Response to referee comment on "Technical note: Turbulence measurements from a Light Autonomous Underwater Vehicle" by Eivind Hugaas Kolås et al., Ocean Sci. Discuss., <https://doi.org/10.5194/os-2021-107-RC1>, 2021

Response to Reviewer 2

"Technical note: Turbulence measurements from a Light Autonomous Underwater Vehicle" by Eivind H. Kolås, Tore Mo-Bjørkelund, and Ilker Fer

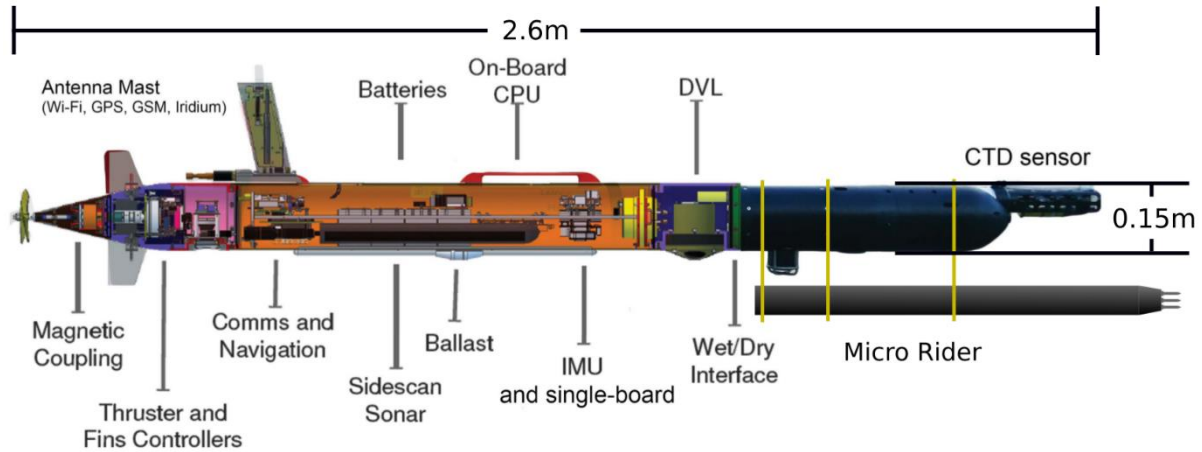
- How is the handling and constraints for deployment and, particularly, recovery?

- *Particulars about the MR mounting, possibly a drawing.*

Deployment can be done from a crane on board the mothership, however, one needs to recover the vehicle from a work boat or similar. This adds constraints on the weather conditions.

The following figure illustrating the setup has now been included in the paper.

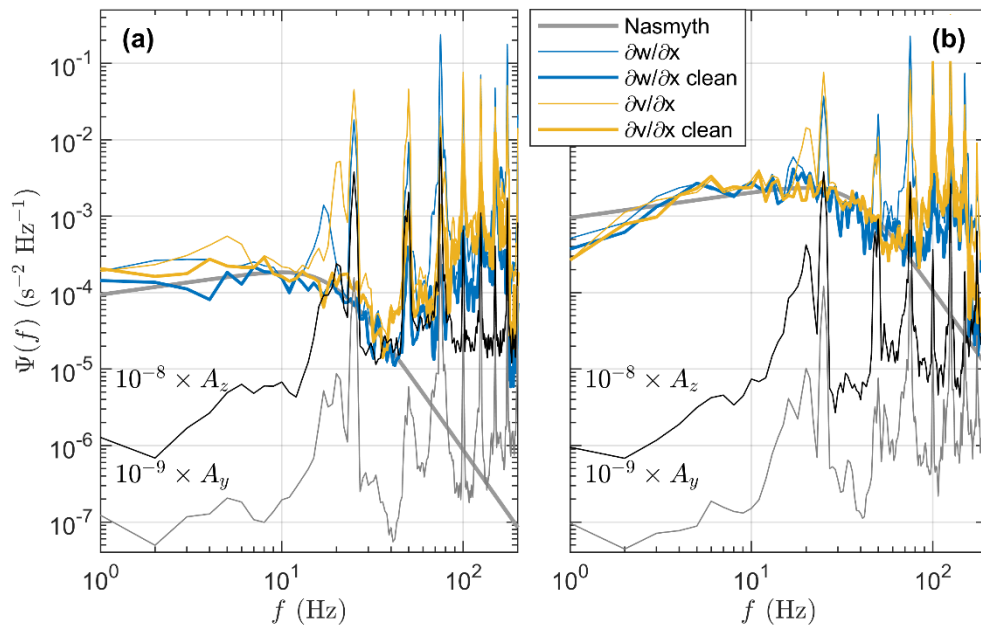
- (L.156) Is there a criterion why change rates of 10° roll/s, 5° pitch/s, and 2 RPM/s have the same consequence?

The final screening done here is based on visual control of the timeseries, where abrupt rate of change of flight behavior can lead to contaminated dissipation estimates. The chosen thresholds delineated these and are used to remove outliers. We've produced scatter plots of rate of change vs dissipation, and decided on rate of change thresholds based on those. A

change in roll is generally a much smaller disturbance on the shear sensor than a change in pitch (because of how the MR is mounted on the AUV), thus a higher value is allowed. There is no criterion why the different thresholds on the different variables should have the same consequence.

We now specify in the processing description that the thresholds in the final screening is based on visual inspection of the rate of change vs dissipation estimates.

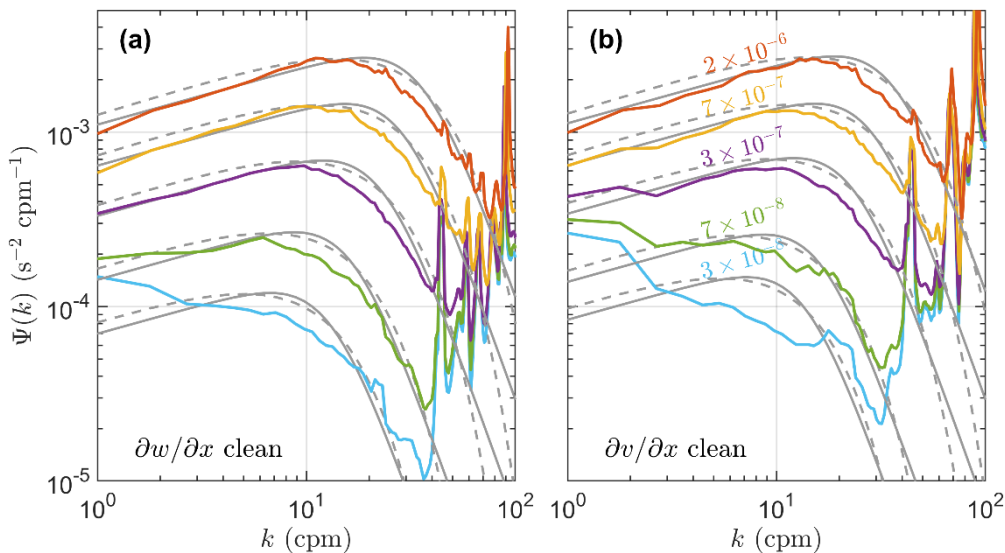
- Fig.5: Suddenly the theoretical Panchev-Kesich spectrum pops up, only in the left panel, without having been introduced before. Its only usage in the paper is in L.218 stating that the spectra resemble both Nasmyth and Panchev-Kesich. However, inspecting Fig.5a, it seems the cleaned spectra fit the Panchev-Kesich spectral shape much better than Nasmyth. (Only the estimated epsilon would result a little lower after a thorough fit.) If so, much of the discussion on early rolloff and spectrum averaging (L.219-224) would be obsolete (L.184 in Results is affected, too). Instead, the interesting question could be discussed why Panchev-Kesich shows the more similar spectral shape.

Thank you for pointing this out. The Panchev-Kesich spectrum is now introduced earlier in the Results section and is now included in both panels of Figure 5 (see attached figure below). In addition, we now produce Panchev-Kesich spectra following the same averaging as for the Nasmyth spectra. In the original version, the Panchev-Kesich spectrum was presented as a reference, plotted using the average dissipation value (hence the roll-off was not smeared out as it would be after averaging over several spectra covering one decade range of dissipation values). Now, the individual Panchev-Kesich spectra (from the individual epsilon estimates) are bin-averaged similar to the Nasmyth spectra and shear spectra. As you point out, the roll-off in our observations does fit the Panchev-Kesich spectra better than the Nasmyth spectra. Yet there is still a systematic offset at the roll-off, and we think this is worth some consideration, hence retain a modified version of the discussion in line 219-224. For wavenumbers between 1 and 10, the Nasmyth spectra fit our observations better for $\epsilon > 1e-7$. A discussion about similarities between our observations and the two spectra is now included.

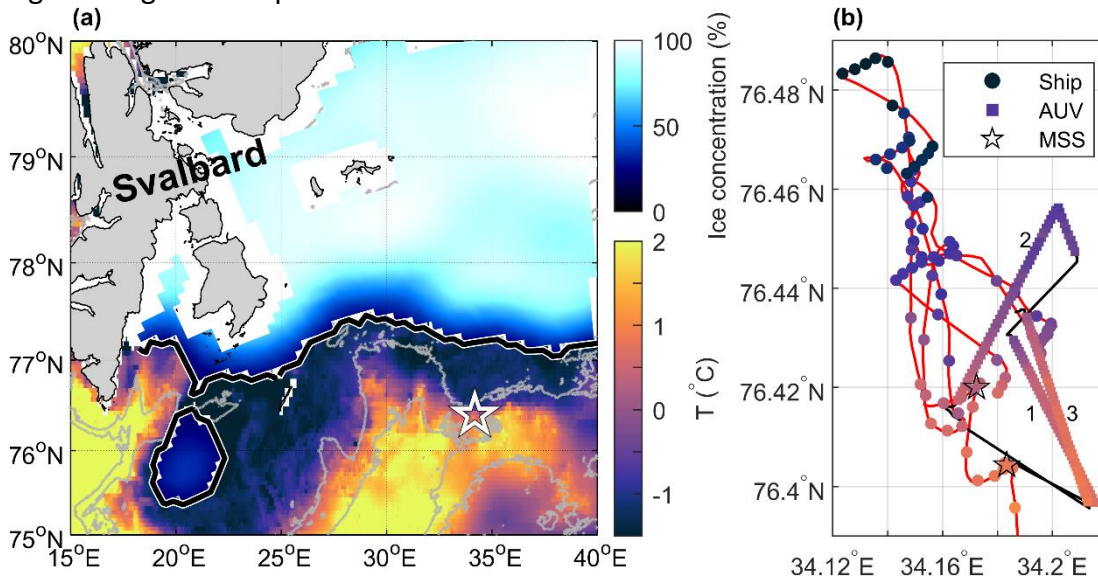
Fig.1a needs more clarity. Isobaths may be negligible. The ice edge is unnecessarily hard to spot, a thicker black line with an overlying dashed white line might be a solution. The experiment location should not be directly on the edge of the plot; expanding to 40°E at least would better support orientation.

Agreed. Figure 1 is updated as shown below.
